South West Rocks

A report with respect to submissions to the
exhibition of the Environmental Assessment &
a Preferred Project Report with
updated Statement of Commitments

PLANNERS NORTH, May 2013

SETTLERS RIDGE, SOUTH WEST ROCKS

Plan 11.2
PEDESTRIAN
PATH
SYSTEM

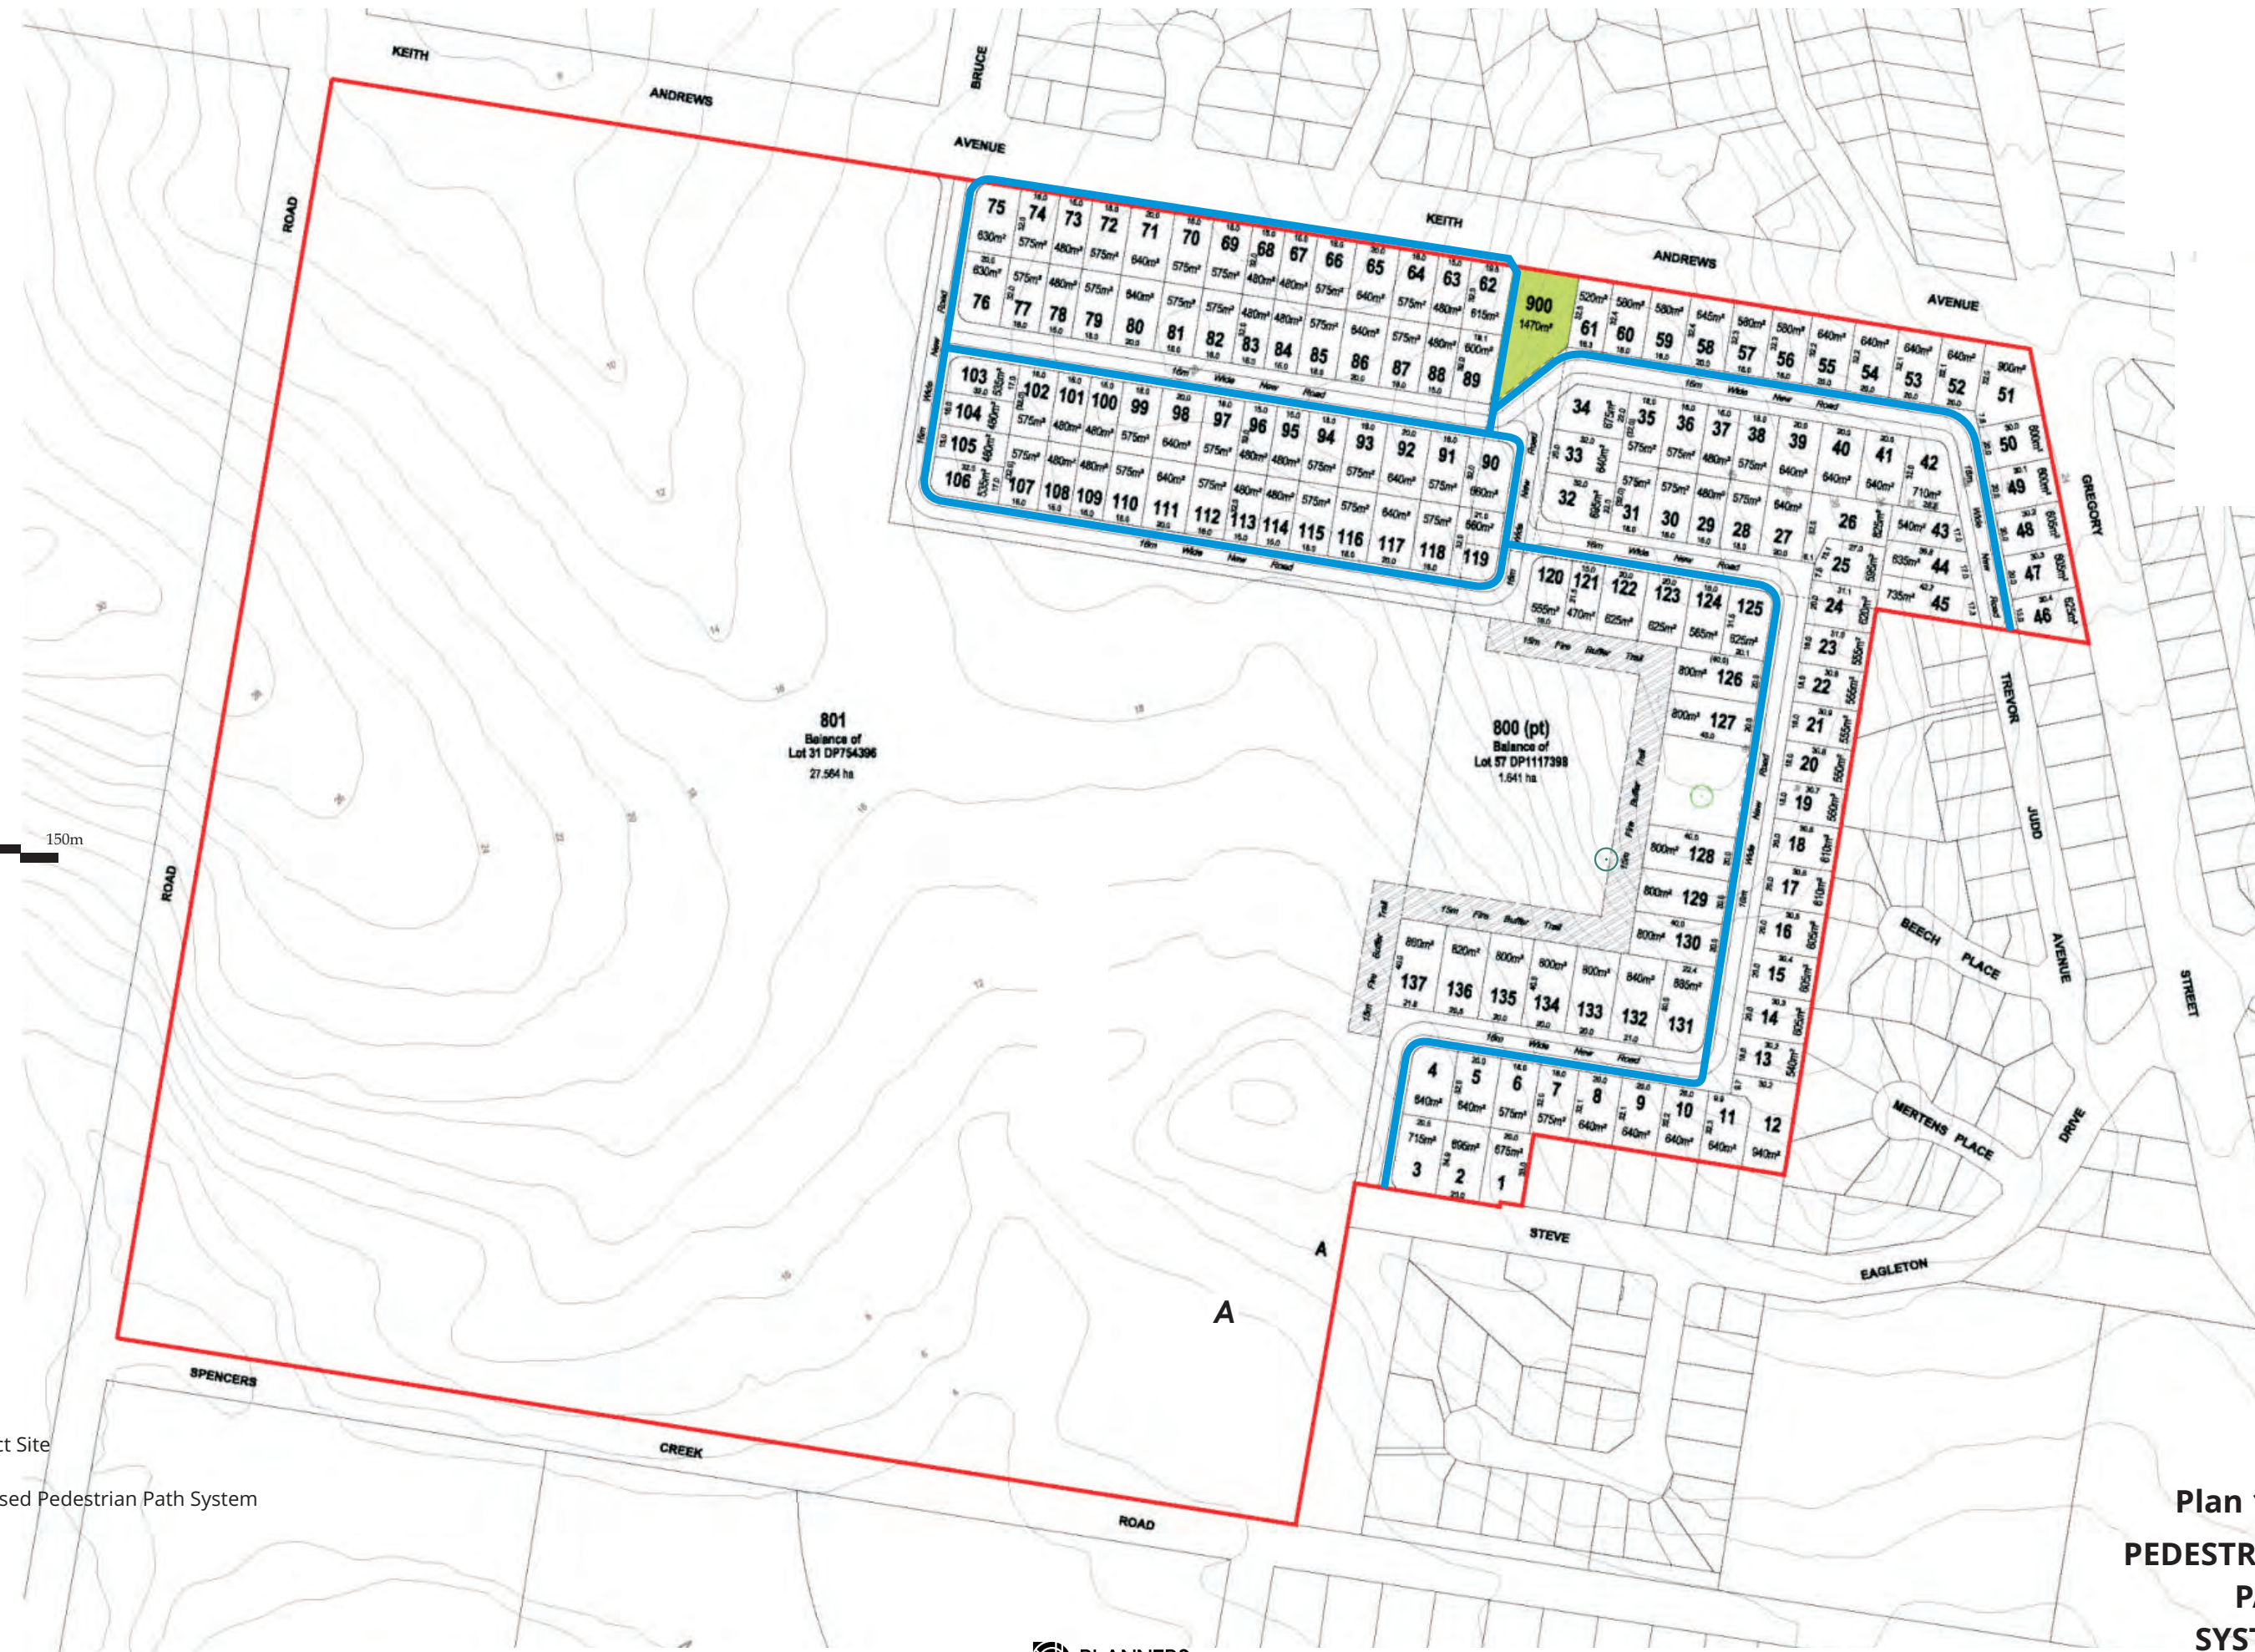
As stated previously in this letter Council has no immediate plans to construct the unmade section of Keith Andrews Avenue from Gregory Street to Rippon Close. Council will not support pedestrian access in this part of Keith Andrews Avenue for the following reasons: -

- Council's Engineering Guidelines for Subdivision and Development D1.16 (5) requires Concrete paths 1.2 m minimum width must be provided in all urban areas, except Access Places less than 75 m in length. The proponent is to amend drawing 5.5 in the EA to correspond to this requirement.

Plans submitted with the Environmental Assessment provide for the interconnection of the pedestrian and cycleway network with the public transport network. Having regard to comments by Kempsey Shire, those plans have been updated with the Preferred Projects Scheme - see **Plan 11.2**.

The proposed pedestrian cycleway network has been modified to have regard to the Preferred Project Subdivision scheme and to the comments set out from Council's submission. The revised pedestrian/cycleway network is illustrated in **Plan 11.2** at Section 11 of this report.

Plan 11.2 shows revised details in relation to pedestrian linkages. This revised plan is lodged as a consequence of Council's request for changes to the pedestrian network (see comment 6.11).
